State of Washington  
DEPARTMENT OF FISH AND WILDLIFE

September 15, 2022

Thank you and Cypress Creek Renewables (CCR) for the meeting on September 9 regarding the High Top and Ostrea Solar Projects (Project). In our July letter to the Energy Facility Site Evaluation Council (EFSEC), the Washington Department of Fish and Wildlife (WDFW) recommended a corridor width of 1-2 miles and based on the project layouts presented in the Ostrea Wildlife Connectivity Analysis, a corridor of approximately 1.2 miles (letter C in Figure 1) will occur between Ostrea East and Ostrea West. In addition, a corridor of approximately 0.3 miles (letter B in Figure 1) will occur between Ostrea West and High Top. As the Project layout is further refined, through either a reduction in panels or changes in micro-siting, WDFW recommends that we be consulted to offer additional areas where Project changes could provide functional corridors for wildlife movement suitable for a diversity of wildlife species.

Figure 1

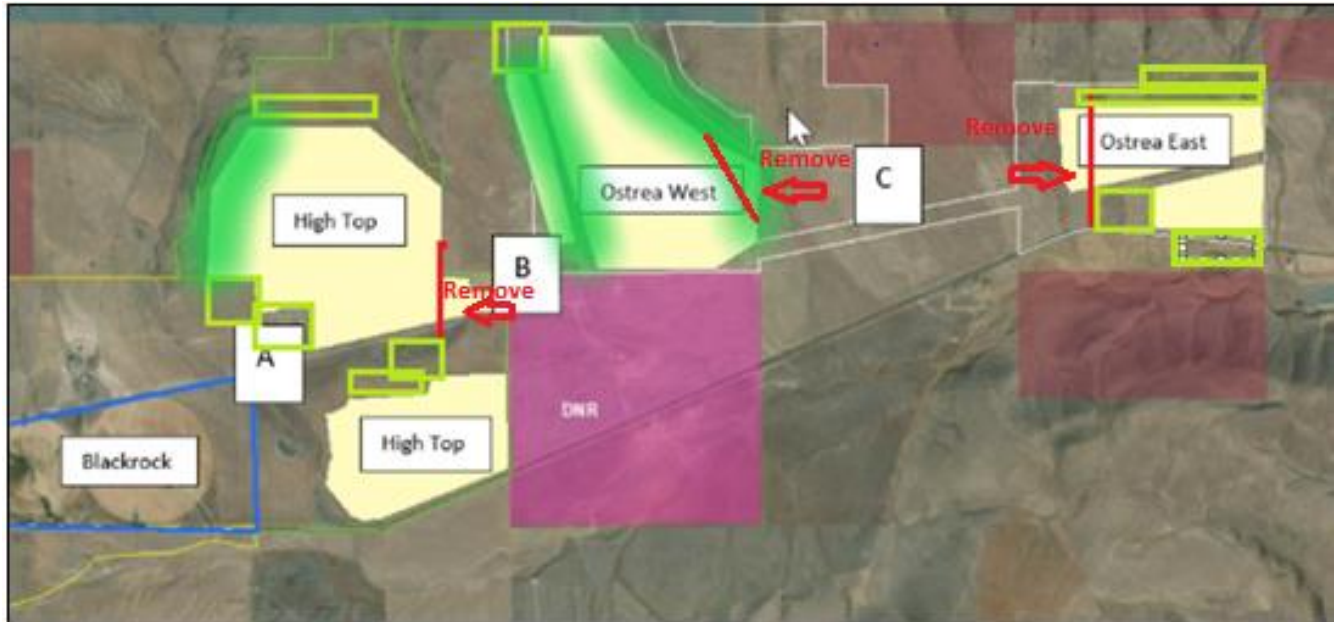
Figure 1 below shows an example of how relatively small changes could be made (red polygons removed) to integrate functional wildlife movement corridors into the Project layout by relocating some panels in more of a north-south orientation (depicted as green polygons). We understand that placing panels within some of these green polygons could result in impacts to shrubsteppe habitat, but the overriding ecological priority is in providing and maintaining wildlife corridors of sufficient width to be functional for wildlife species present. We also understand that the red polygon on the southeastern tip of High Top is where a substation is proposed. It is preferable that the substation location be shifted to the west so as not to intrude on the function of the wildlife movement corridor and be more "centered" between High Top North and High Top South.

Additionally, wherever the Project margins are adjacent to grade breaks such as wildlife movement corridors located within dry creek beds or arroyos (such as the western edge of corridor C in Figure 1), or where two arrays are on opposite sides of a corridor (shaded green in Figure 1), we recommend that consideration be given to setting back the panels a sufficient distance from the edge of the "grade break" to preclude "line of sight" view by wildlife using these creek beds, as shown in the Figure 2 below. Whenever project facilities are out of sight, wildlife exhibit less disturbance.
